ADDENDUM

RFB NO. 318036 - ADDENDUM NO. 1

SHOP BUILDING CONSTRUCTION

DANE COUNTY LANDFILL SITE NO. 2 (RODEFELD)

TRUE NORTH
 PLAN NORTH
 SCALE: 1" = 30'-0"
A101

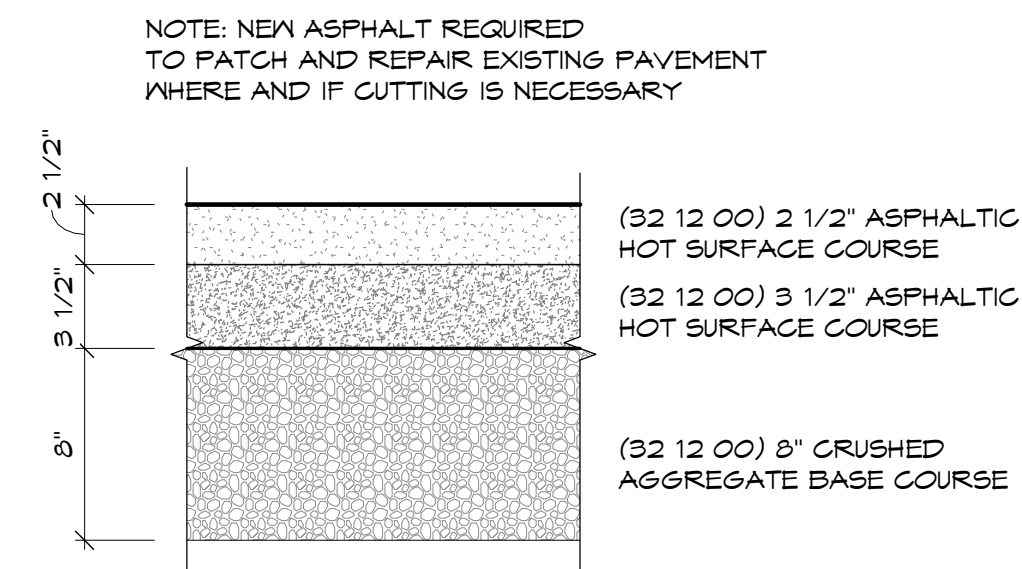
The man gate has been eliminated.

The light pole shown north of the proposed building has been eliminated. Existing Contractor for the biogas facility will be installing a new light pole in the approximate location shown on the revised sheet.

The fencing and gate shall be revised as shown terminating at the northwest corner of the proposed shop building.

The new gate shall be a 15’ wide double leaf manual gate with locking hardware able to receive a padlock.

1 Site Plan
 1" = 10'-0"

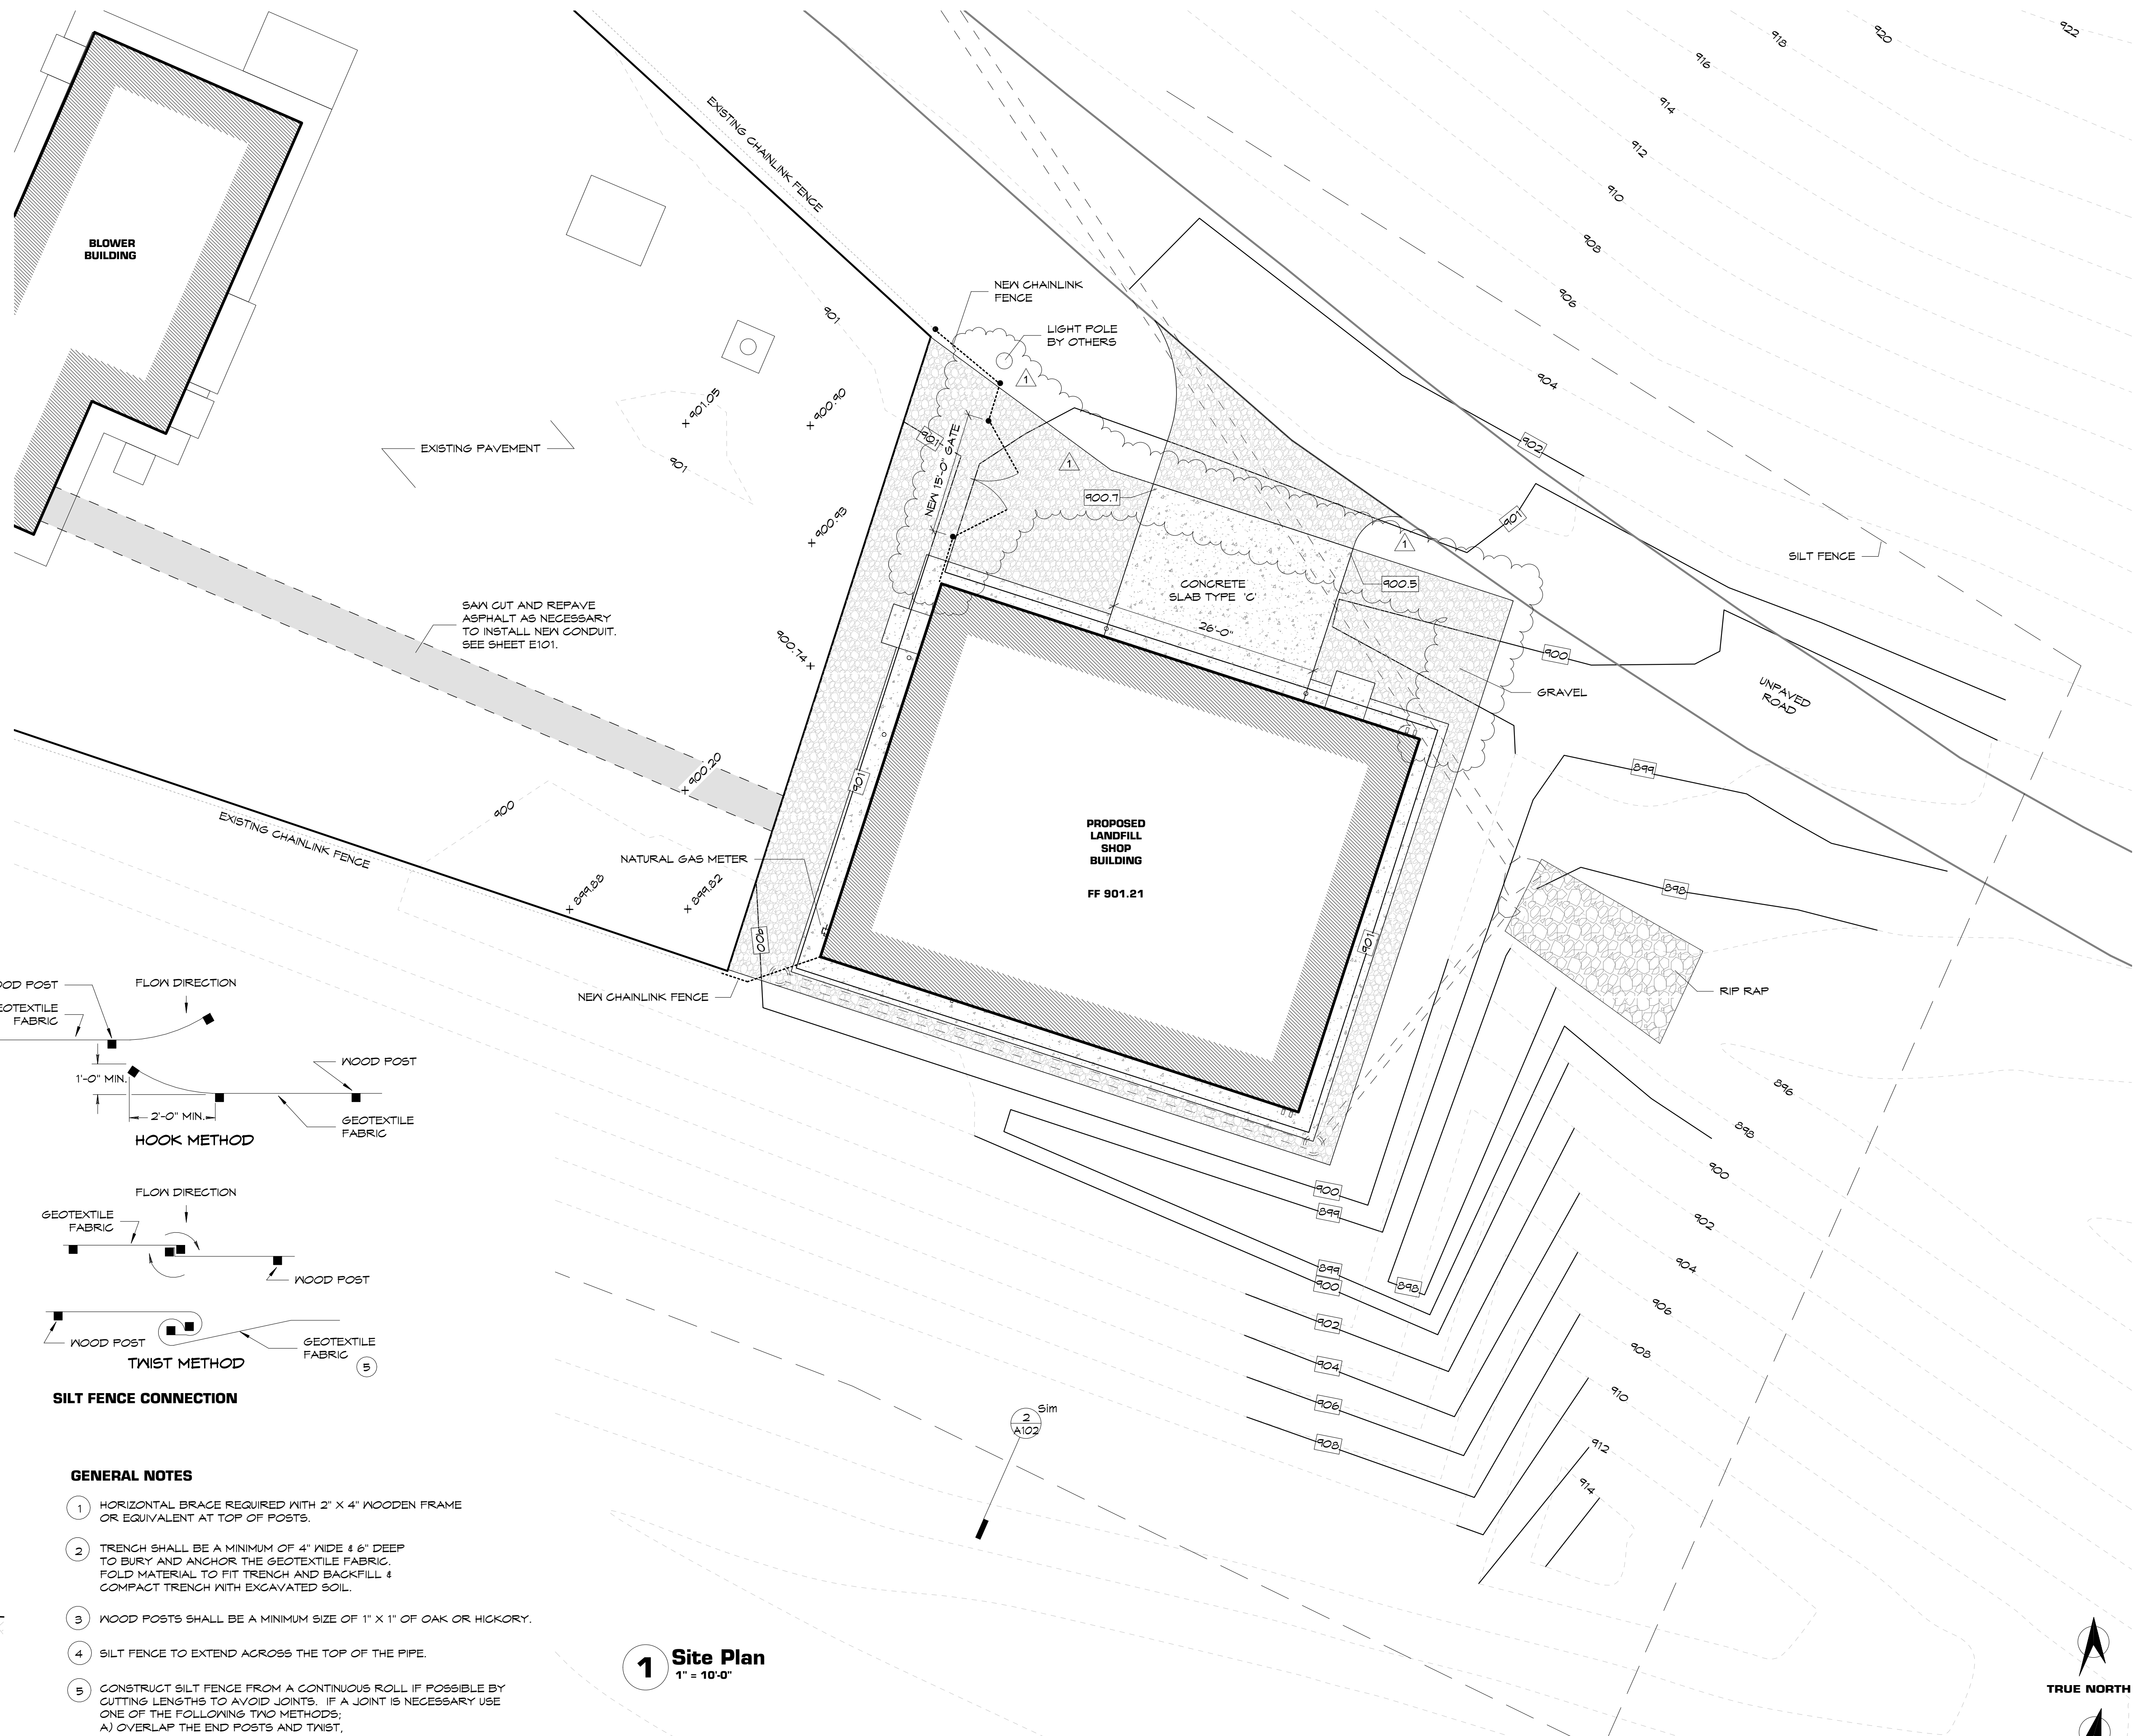
The man gate has been eliminated.

The light pole shown north of the proposed building has been eliminated. Existing Contractor for the biogas facility will be installing a new light pole in the approximate location shown on the revised sheet.

The fencing and gate shall be revised as shown terminating at the northwest corner of the proposed shop building.

The new gate shall be a 15' wide double leaf manual gate with locking hardware able to receive a padlock.

1 Floor Plan - Overall
1/4" = 1'-0"

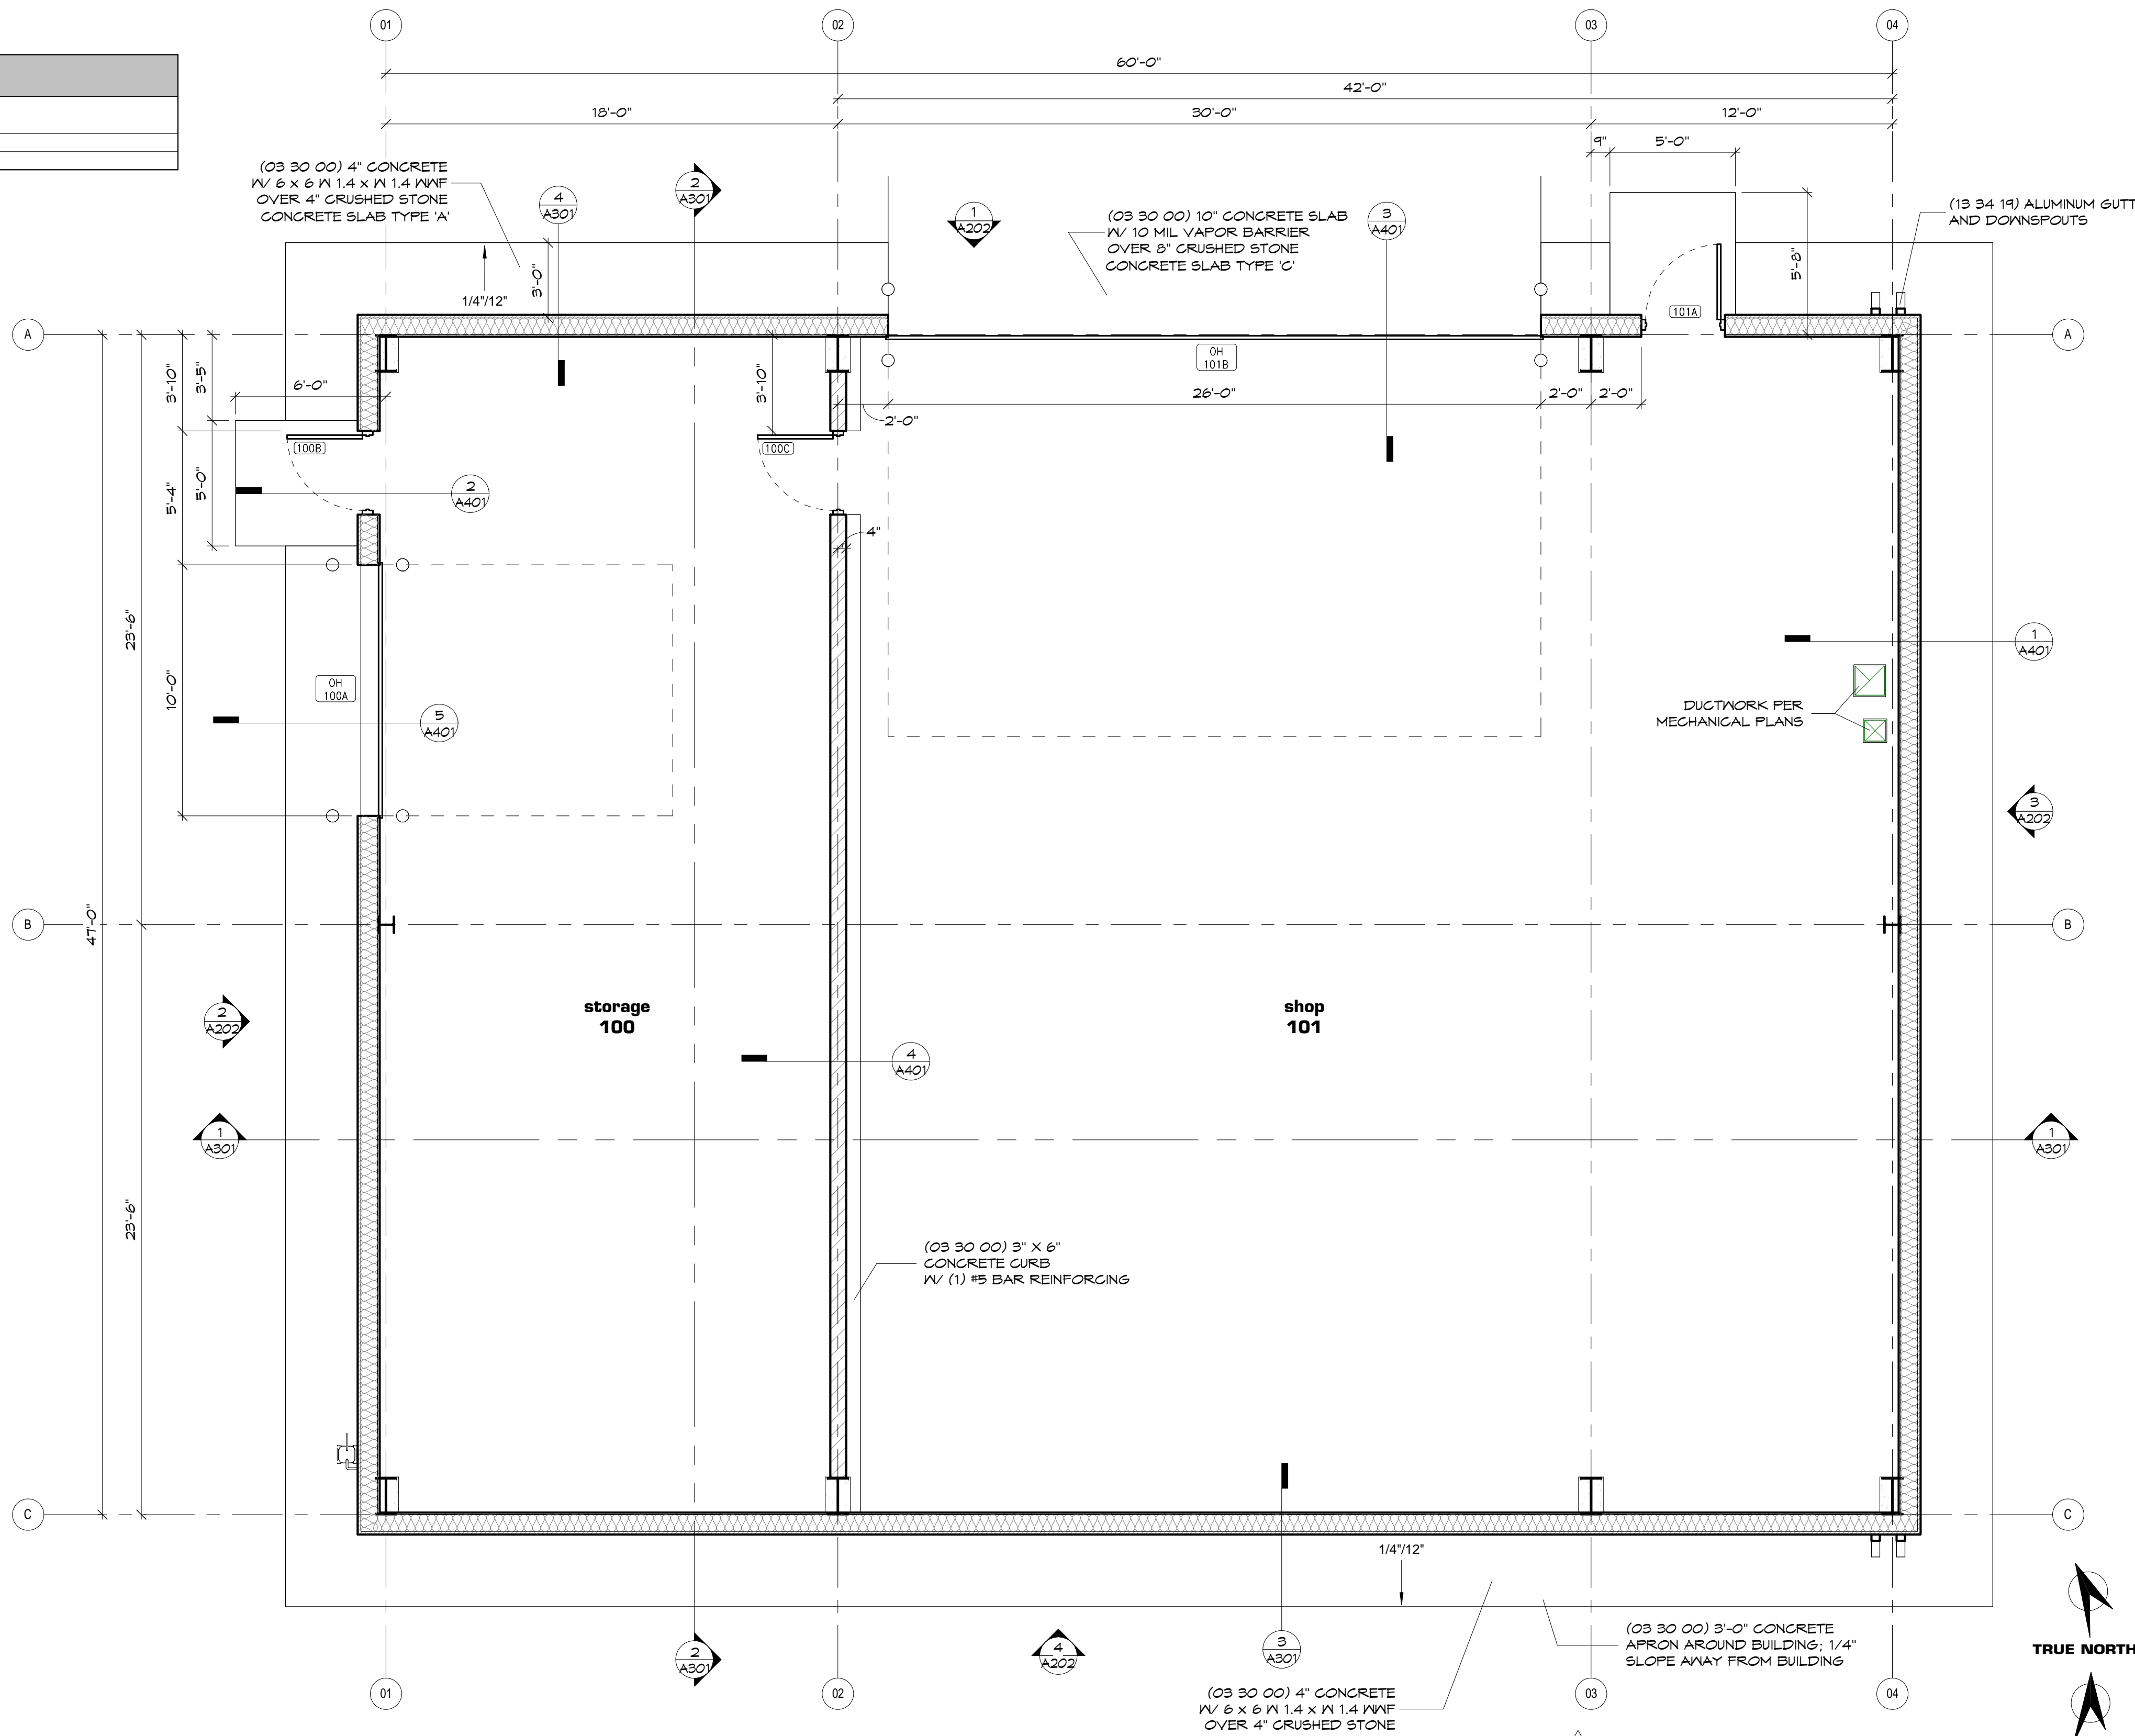
Previous version stated Room Schedule, Floor Type as Polished Concrete. The revised version does not have Polished Concrete. Slab on Grade to be standard concrete with hard trowel finish.

Paint Schedule notes Floor to receive Densifier: Per Specification Section 03 30 00, Densifier refers to Ashford Formula or equal.

Concrete apron around building is 3' - 0" with 4" concrete over 4" crushed stone as detailed on Sheet S901, Detail 3. Service door stoops are also 4" concrete over 4" crushed stone as detailed on Sheet S901, Detail 3.

The 26' - 0" concrete apron in front of OH 101B shall be Concrete Type 'C' as noted on Sheet A102 and detailed on Sheet S901, Detail 5.

Attachment A - Revised Conduit Layout

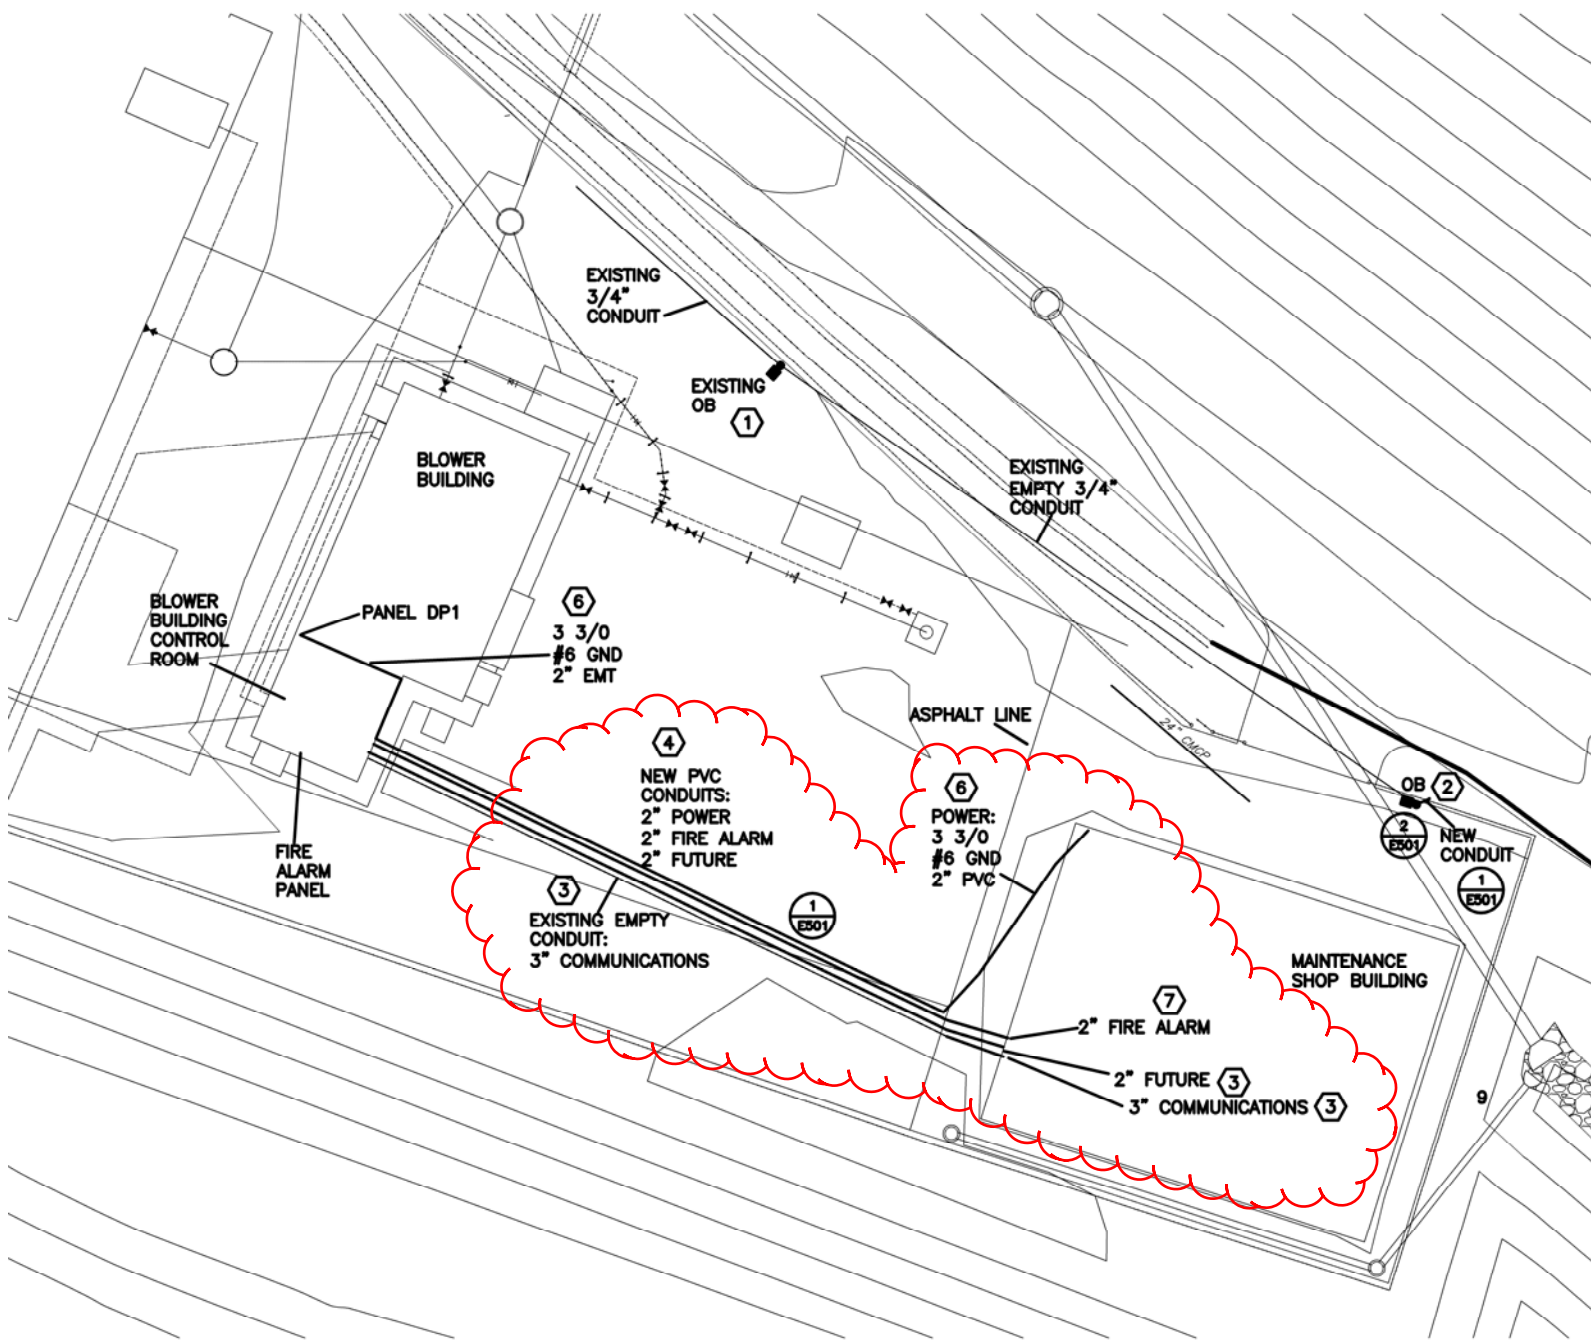
There is one 3" existing conduit from the Blower Building to the edge of asphalt.

Three additional 2" conduits will be run for power, fire alarm, and future use from the wall penetration at the Blower Building to the edge of asphalt by Others.

Contractor is responsible for connections and conduit within the Blower Blower and extending conduits from edge of asphalt into Shop Building, as required.
